# Product Support Bulletin 2009-009

## Maintenance of Way ~ Work Equipment Bulletin

**SUBJECT:** Interior Cab Lighting Kit – 98760056

**MACHINE MODEL(S):** TRIPP – Tie Exchanger

**Figure 1**

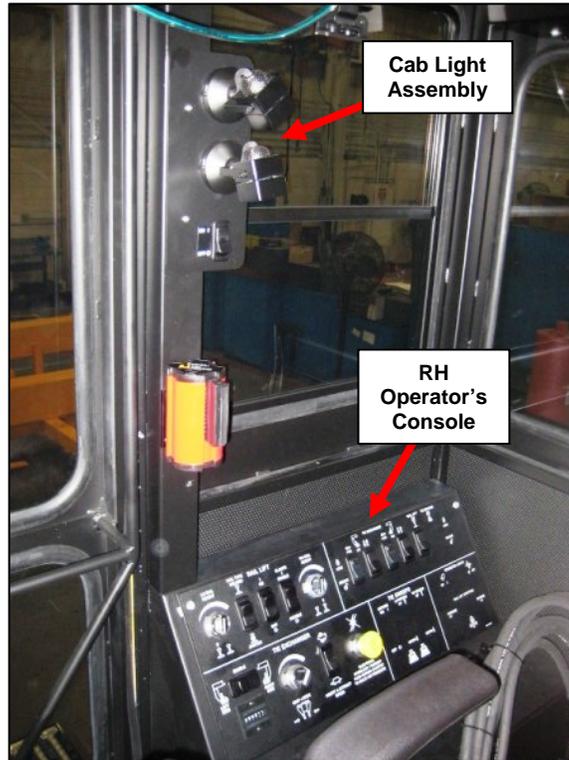
**OPERATIONAL IMPACT:** The switches on the Right Hand Operator's Console may be difficult to see at night or during bad weather. The lights in this kit will illuminate that area of the cab enhancing visibility of the various switches. See Figure 1 on Page 2.

**Figure 2**

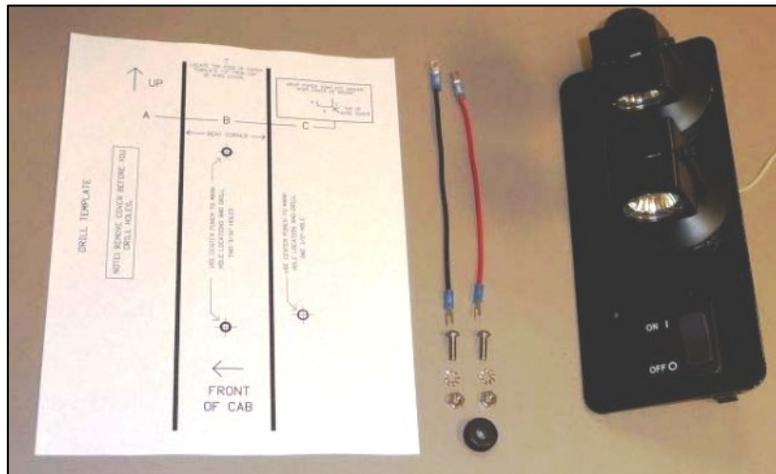
**ACTION:** This kit is easily installed in any TRIPP machine with a 2-door cab. It is not designed to be installed in cabs with only one door. The kit consists of one fully assembled Light Panel, installation hardware and installation instructions. See Figure 2 on Page 2. Installation consists of mounting the Light Assembly in the cab and wiring it to the 24 to 12-volt Power Converter mounted inside the Right Hand Operator's Console. **CAUTION: The bulbs in this kit are 12-volt bulbs. The lights MUST be wired to the 12-volt output terminals of the 24 to 12 volt Power Converter. Failure to connect the bulbs to the 12-volt terminals will cause the bulbs to burn out.**
